2025-78 Radio Tower Painting

Addendum #1 – May 27, 2025

**SUBJECT: TOWER MAINTENANCE INSPECTION
Frankfort, IL
200' Rohn SSVMW Self Supporting Tower**

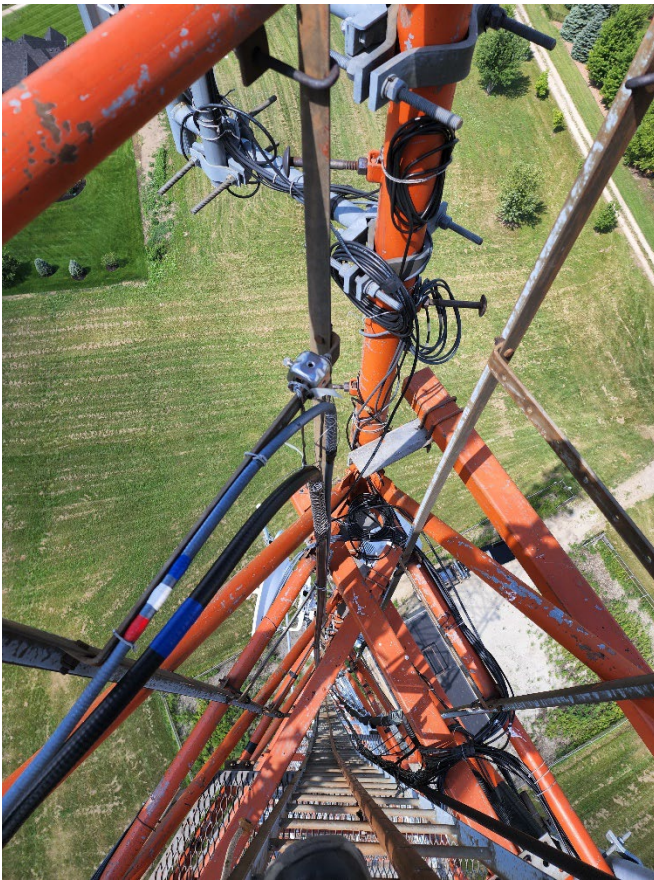
Issue 6 – wi fi clamps should be Valmont Pucks or cross over clamps
